Planning and Referral Agency Comment Letters – presented in reverse chronological order

Re: Comments for Case AN-265-22, Z-984--22, V-94-22

TO: Anita Riley, Planner
FROM: Lee Alverson, Development Review Engineer
DATE: June 8, 2022
SUBJECT: AN-265-22 Z-984-22 V-94-22; 7001 Colorado Blvd, 2nd Comments

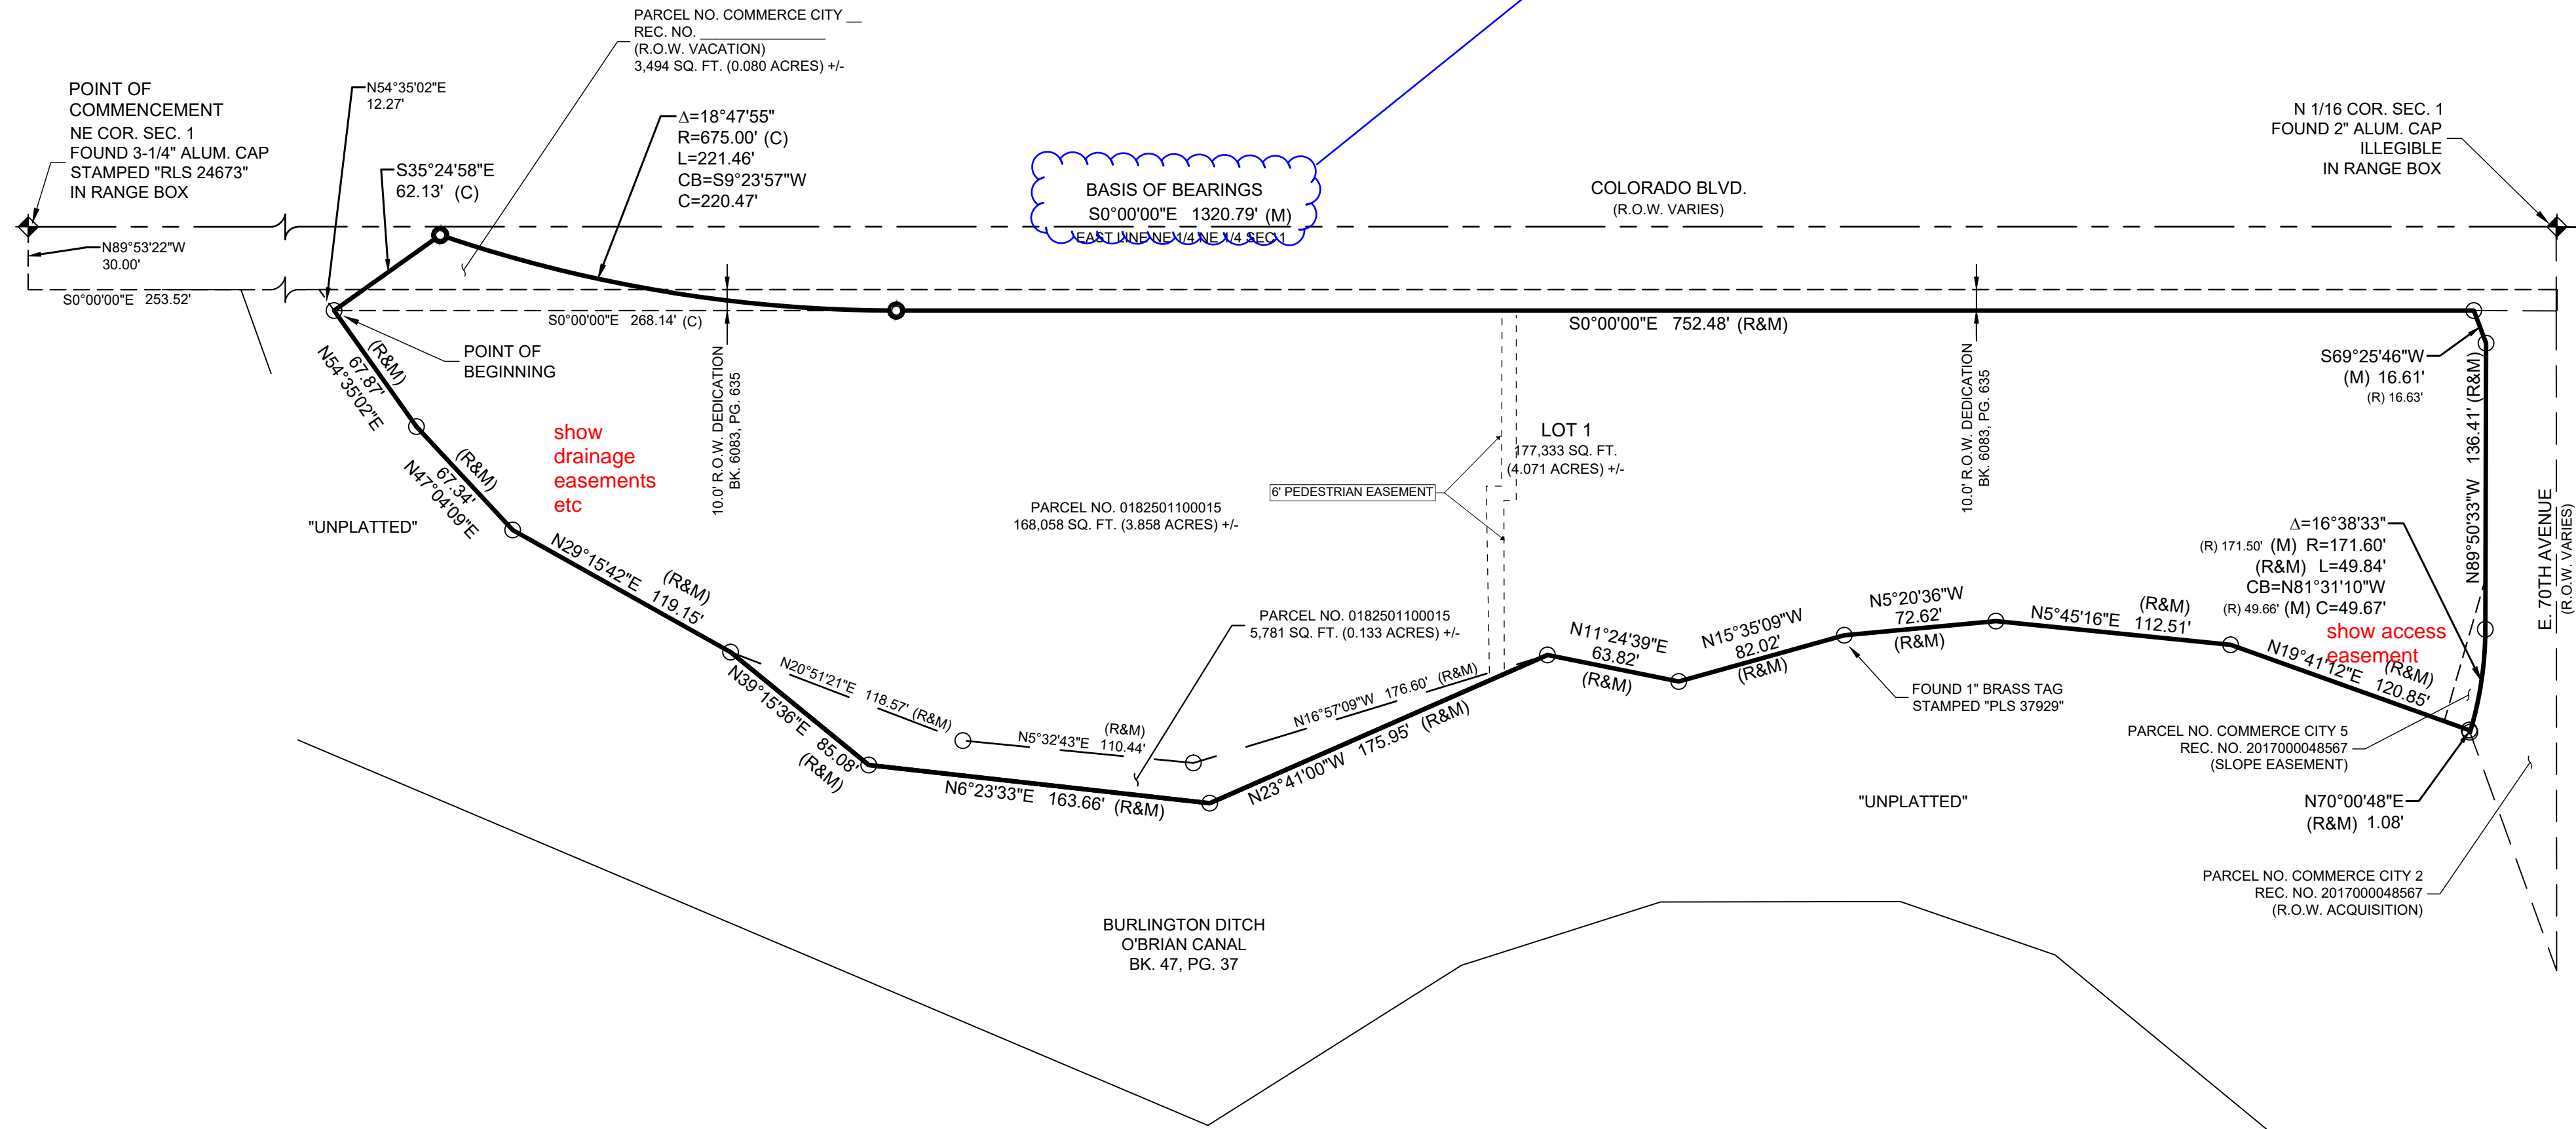
1. The basis of bearing is inaccurate. Basis of bearing for the plans must tie and be rotated to an established point in the Commerce City Control Point System. Benchmark locations, elevations and bearings may be obtained from the engineering department of Public Works. Contact Rose Clawson for more information.

AN-265-22 ANNEXATION MAP
TO THE CITY OF COMMERCE CITY, COLORADO
FOR ANNEXATION PURPOSES ONLY

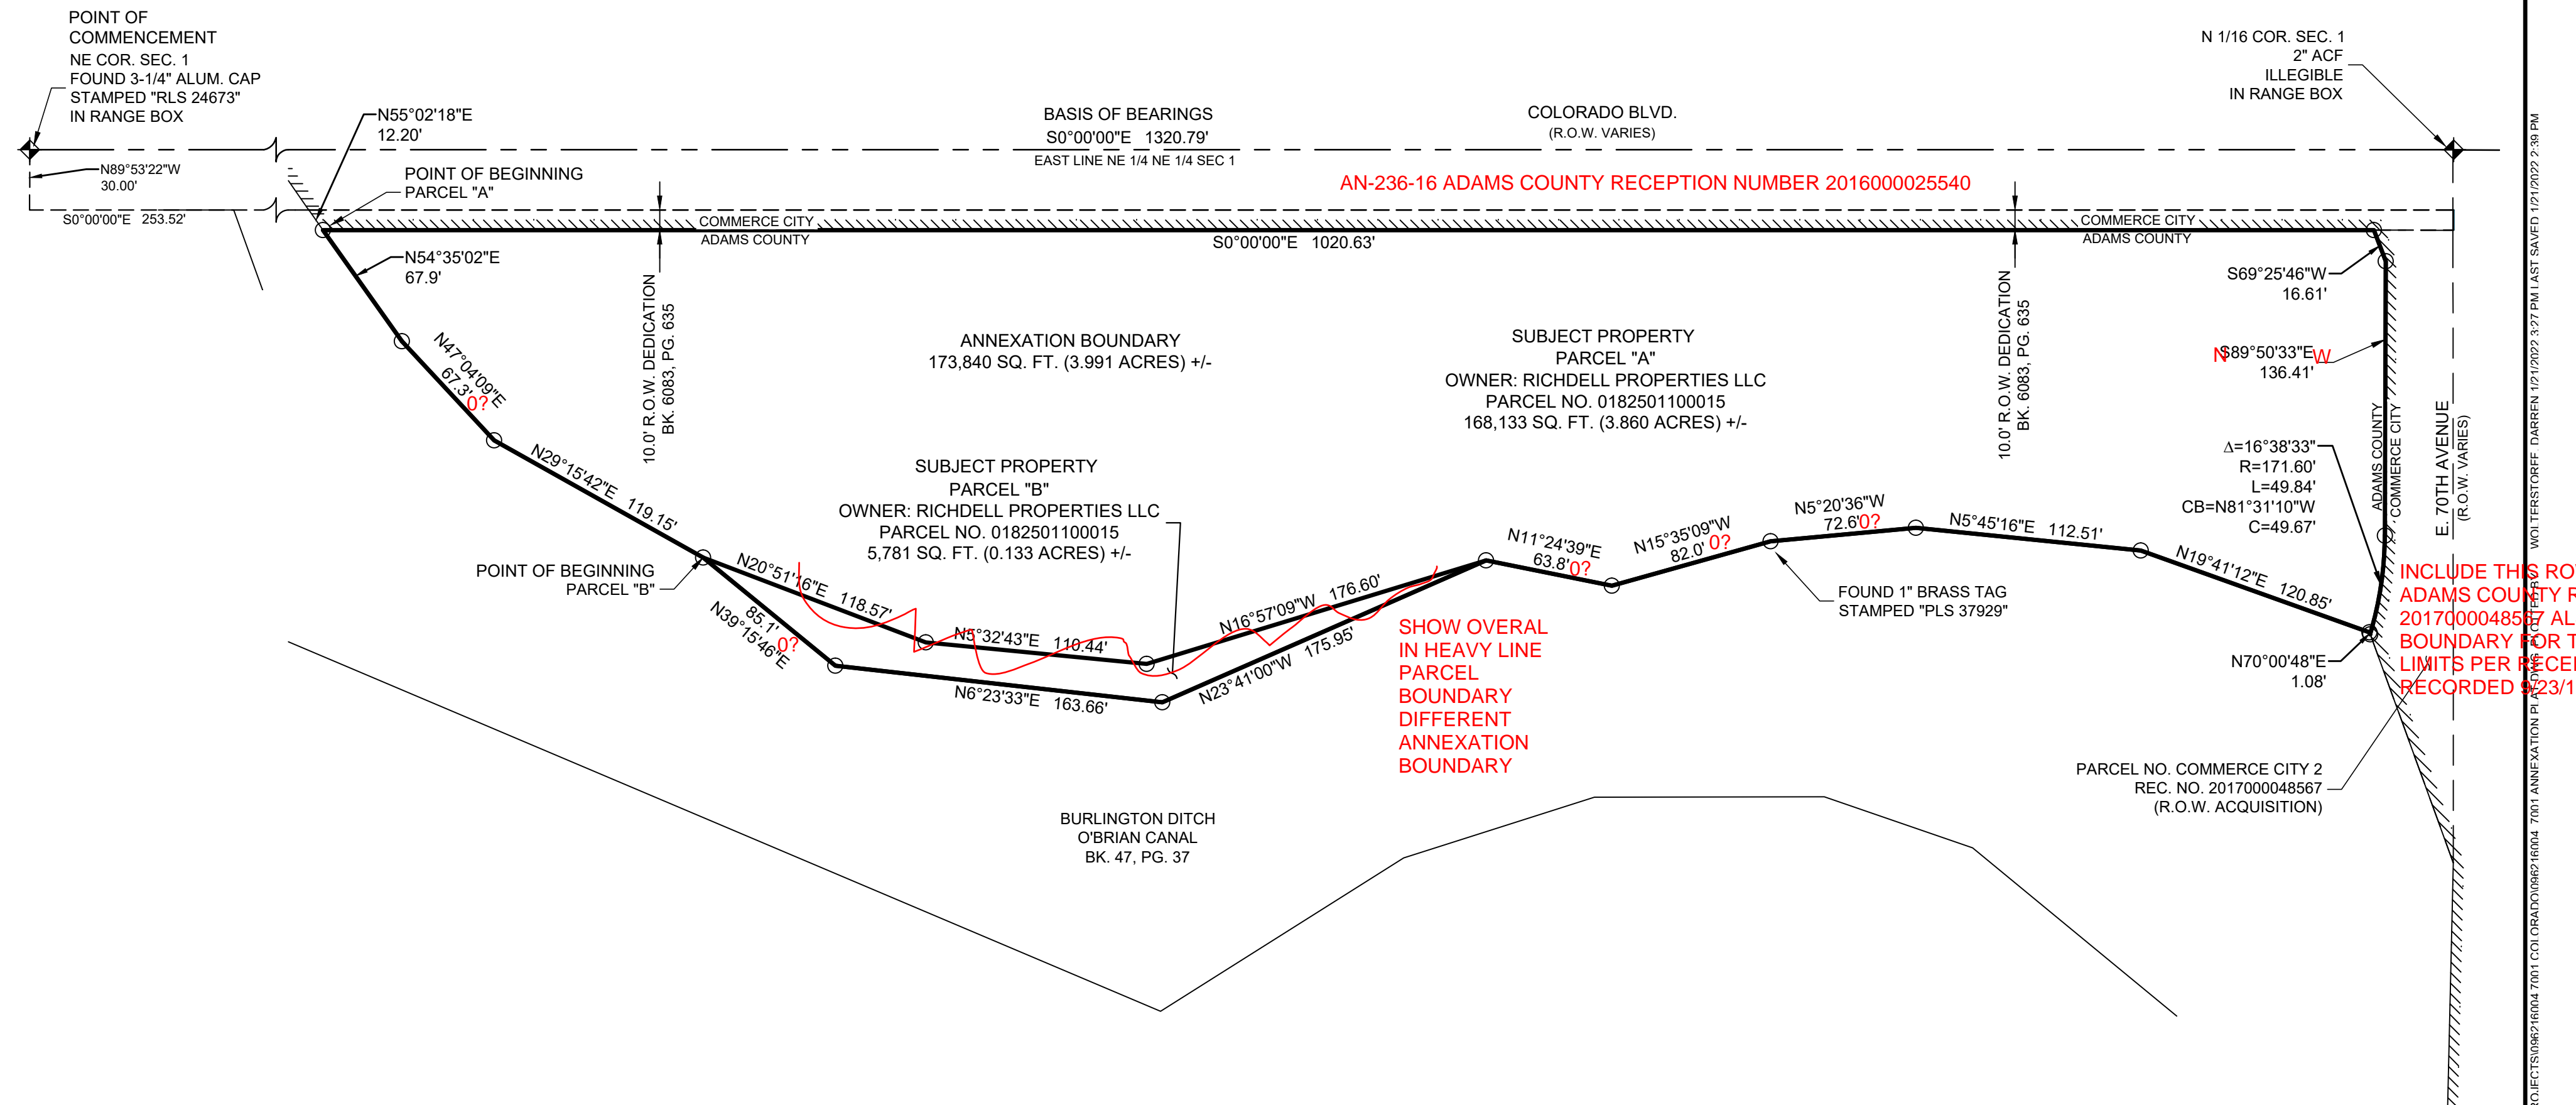
1. This zone change has been assigned case number Z-984-22. Please update the title in the annexation map to reflect this on the next submittal.
 2. Section 21-4310 of the LDC requires a 30-foot side yard setback where the side in on a street. The applicant may provide a second minimum side yard dimension to reflect this requirement or revise the existing minimum requirement shown since there is no interior side to the lot.
